Re: Proposed Replacement Well
Savage Service Corporation
Savage Coal Terminal
C/007/0022

Title: Proposed Replacement Monitoring Well

SAVAGE COAL TERMINAL

WATER MONITORING LOCATION MAP

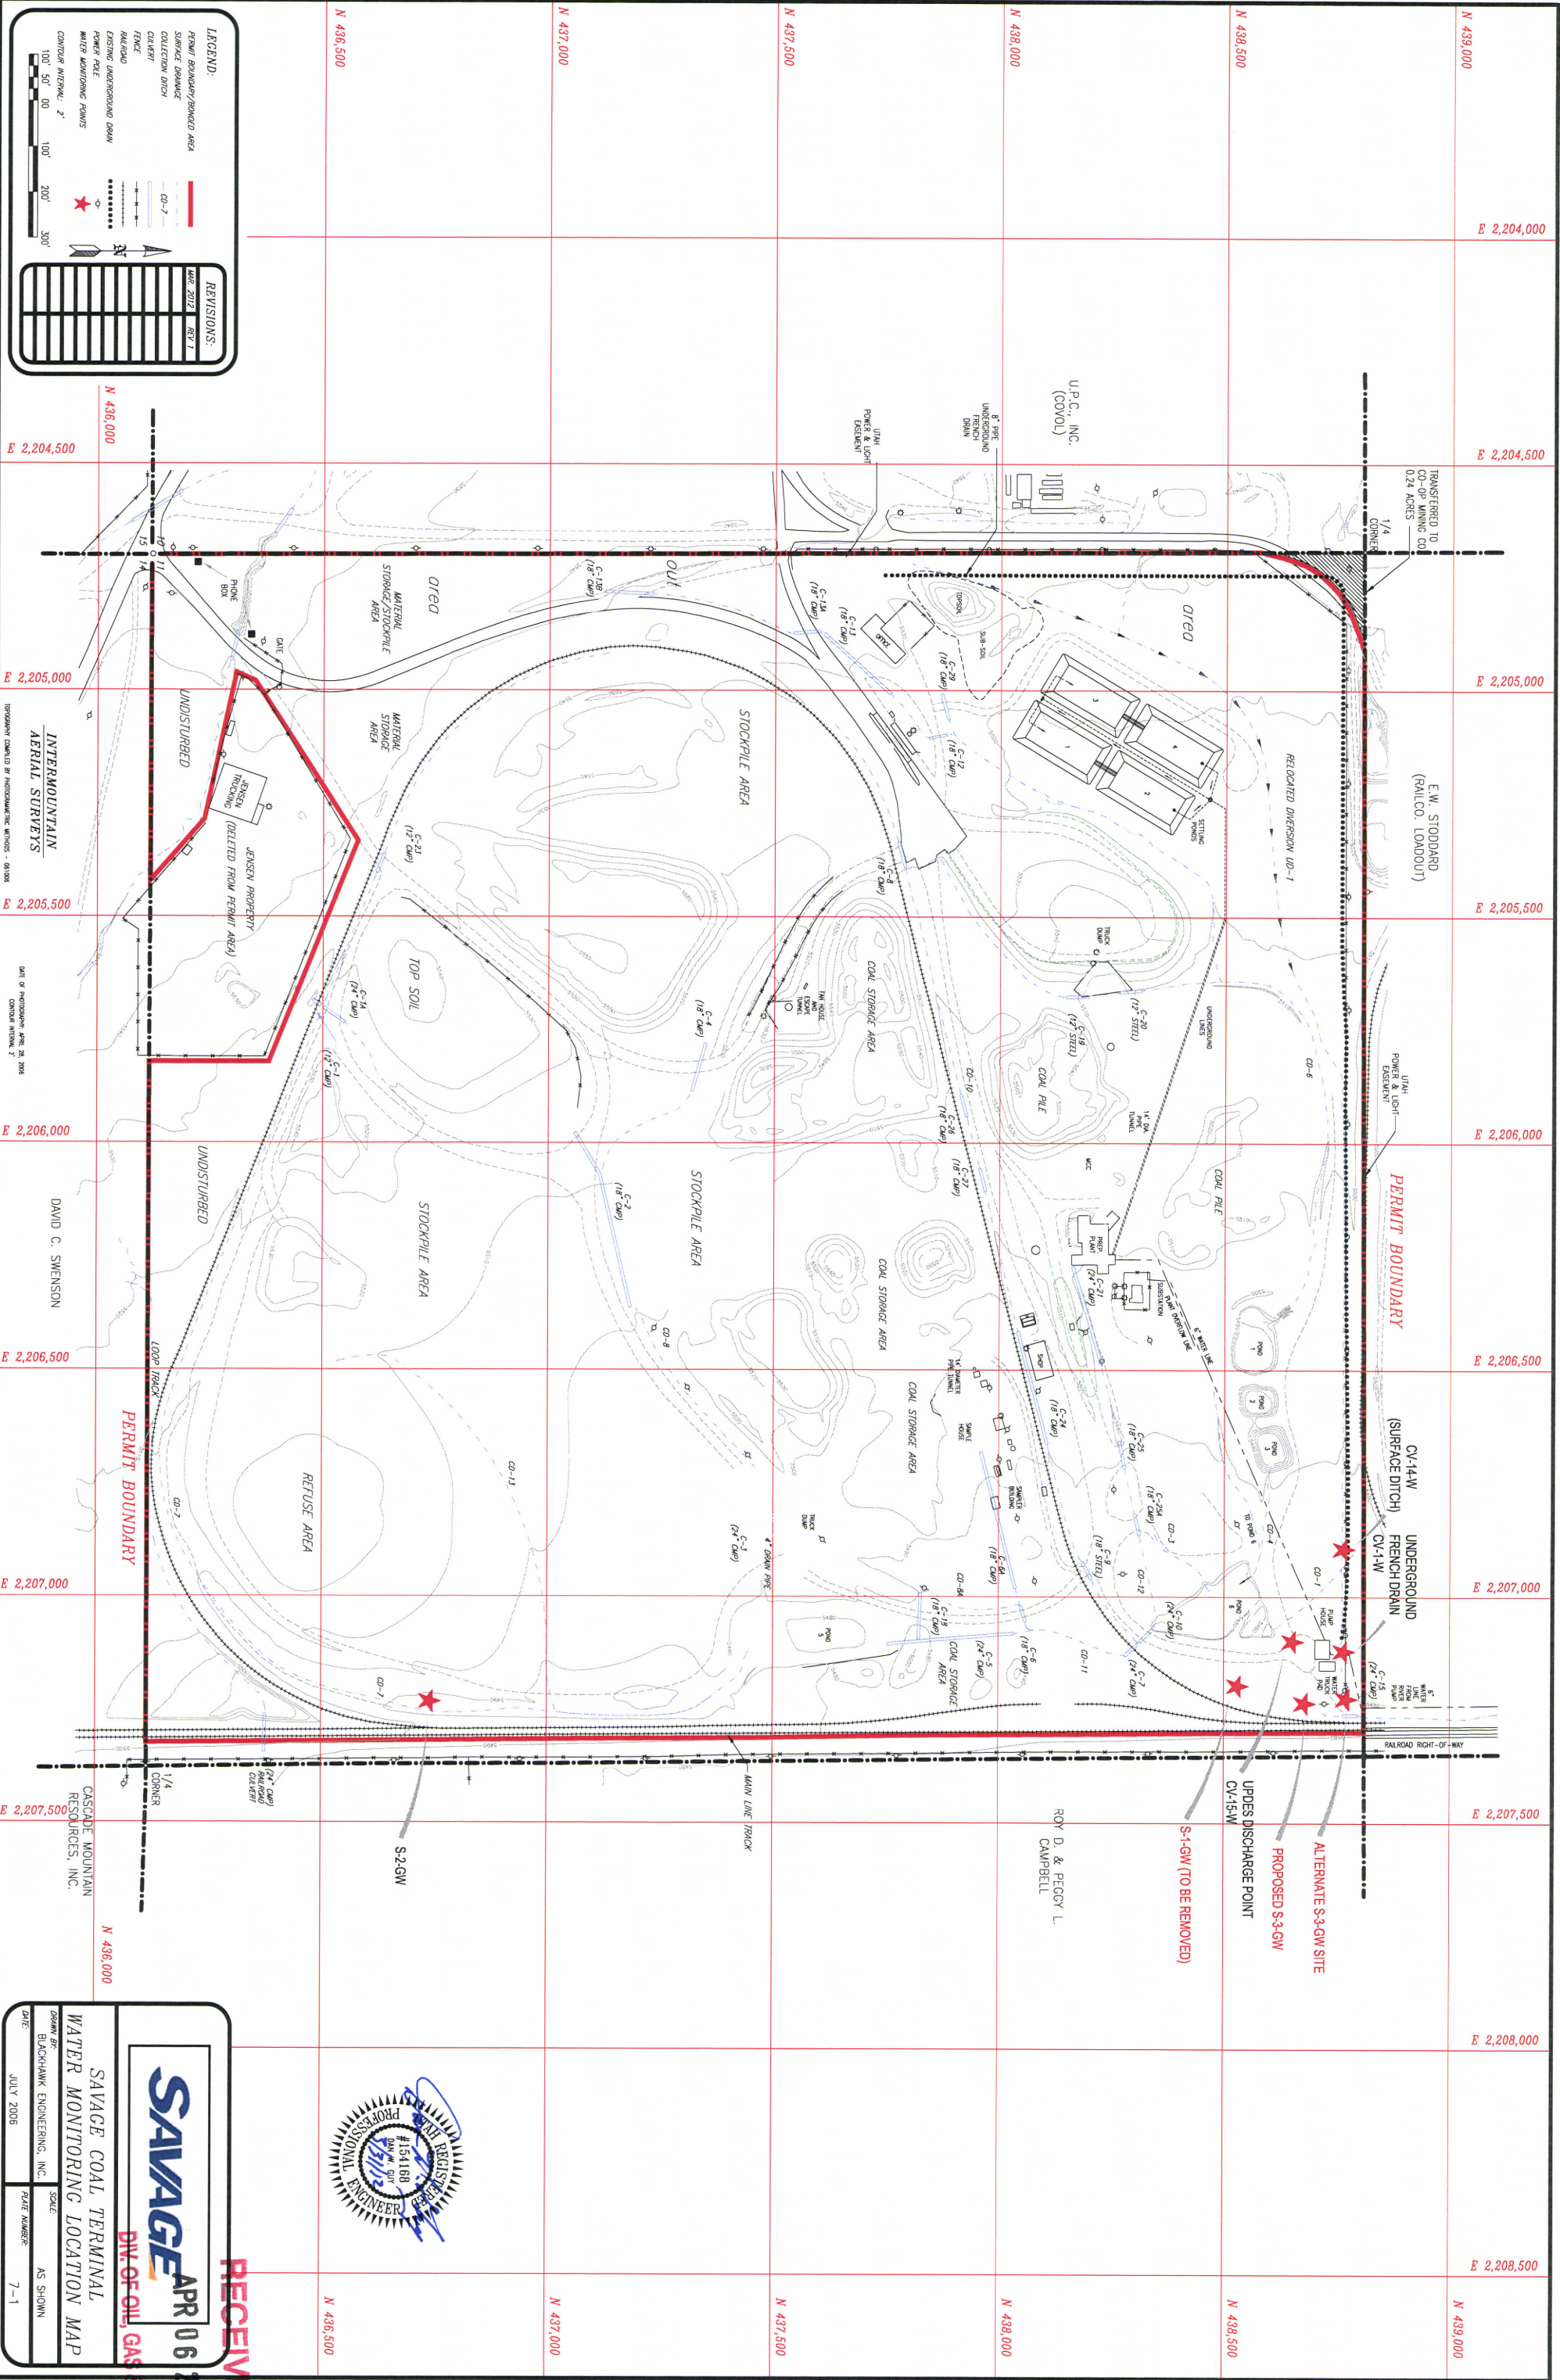
Enclosed are 4 copies of a proposed amendment to the Savage Coal Terminal MRP for the installation of a new ground water monitoring well to replace the dry well S-1-GW. The new well will be designated S-3-GW. The proposed new well location is shown on enclosed Plate 7-1. An alternative location is also shown on the plate, in case the first location is not successful. The well will be installed by a licensed driller, under the direction of JBR Environmental Consultants, Inc.. This submittal is being made to address the Mid-Term Review deficiency under R645-301-728 & -765 (AAA), per the commitment in the cover letter. As indicated in that letter, the installation of the new well will take place within 30 days of Division approval of the amendment..

- 731.200. There are presently 2 surface water monitoring points and 3 groundwater monitoring stations at the Savage Coal Terminal. One of the monitoring wells (S-1-GW) has not provided any information. This well will be replaced by a new well (S-3-GW) to be drilled north of the existing well. S-1-GW will be decommissioned as described under R645-301-748. All other ground water monitoring wells have been removed and sealed as of May 1999. The following is a list of existing water monitoring stations, along with sample frequency:

*S-3-GW will replace S-1-GW. S-1-GW is to be removed and backfilled.

- 747.300 See Section 528.330.
- 748 All decommissioned water monitoring wells have been plugged and sealed as approved by the Division. Existing groundwater monitoring well S-1-GW will also be decommissioned after a new well (S-3-GW) is completed. The well pipe will be cut off at least 6" below existing ground level. The well pipe will then be backfilled with sand or other fine native material to within 12" of the top of the pipe. The upper 12" will then be filled with concrete and the site backfilled to existing ground level. The 2 remaining water monitoring wells, French Drain collection sump and river pump well are shallow, water systems. They will be reclaimed according to the approved plan as described here and in Section 540 of this permit.
